ADDENDUM NO. 2
December 5, 2014

- A. USC Historic Horseshoe Wall Restoration

- A. Stubbs Muldrow Herin architects, Inc.(SMHa)
400 Hibben Street, Mt. Pleasant, SC 29464
(843) 881-7642

H1 ENLARGED ENTRY PLAN AND ELEVATION
SCALE: 1/4"=1'-0"

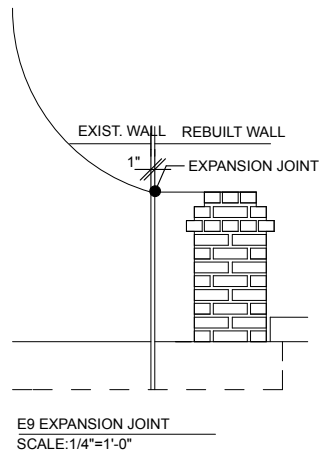
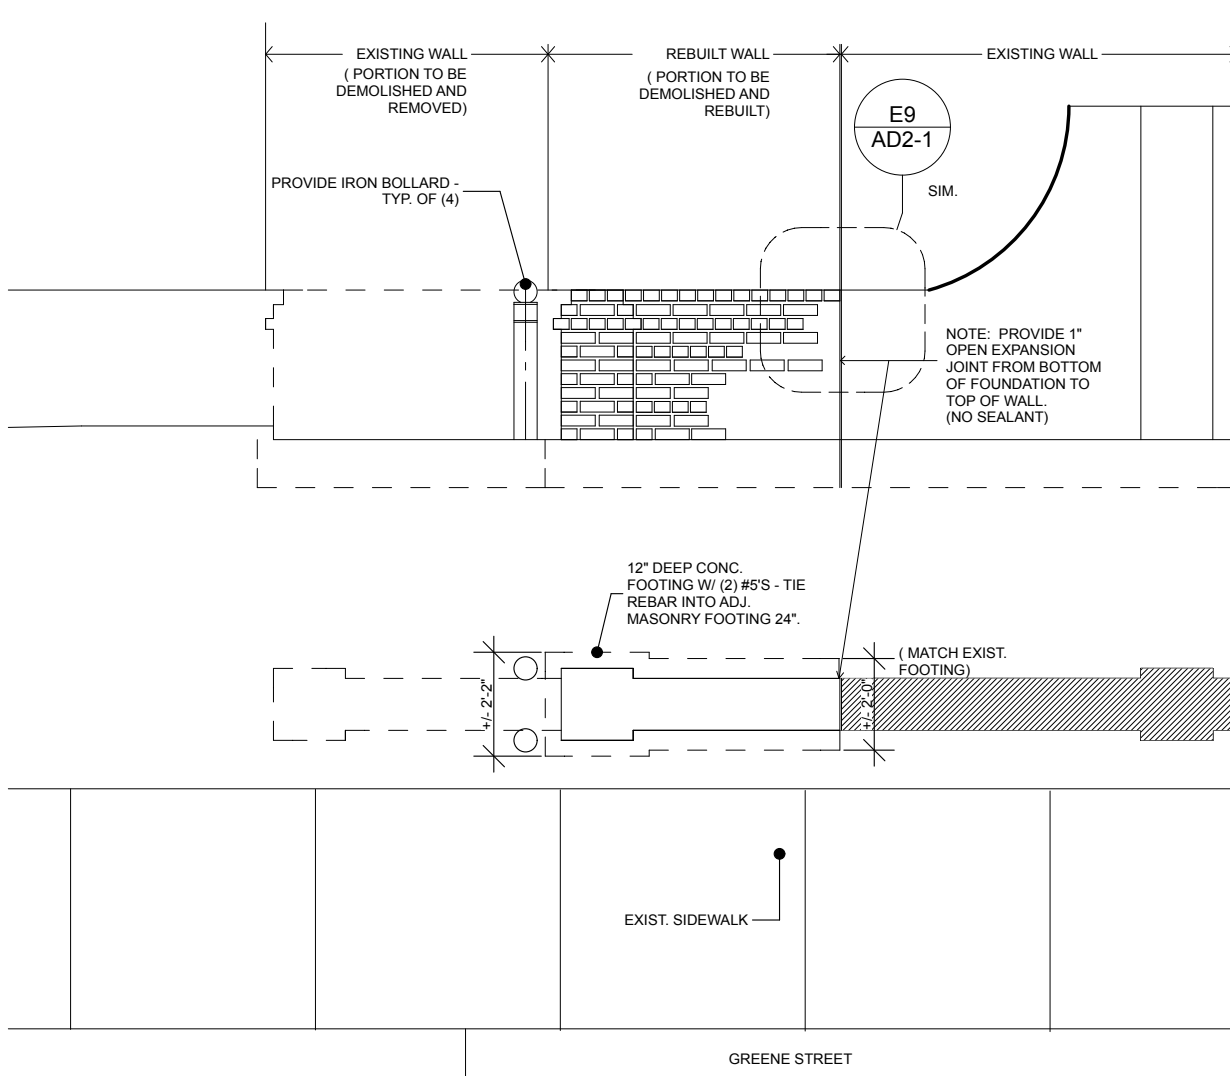
- A. Delete Sheet A302. Add sheets AD2-1 and AD2-2 attached to this document. The bollard shall be the USC standard bollard. See attached USC Standard for Site Amenities Bollard specification and installation detail.
- B. Sheets A100 and A301 Detail J5. Each of the two french drain piping segments shall be connected to a discharge point in a gravel dry well. The well shall be a 2' x 2' x 3' area excavated out and filled with #57 stone, with a filter fabric wrap on all sides. The dry well locations shall be determined in the field but shall be within 15 LF of the piped segments as shown on Sheet A100.
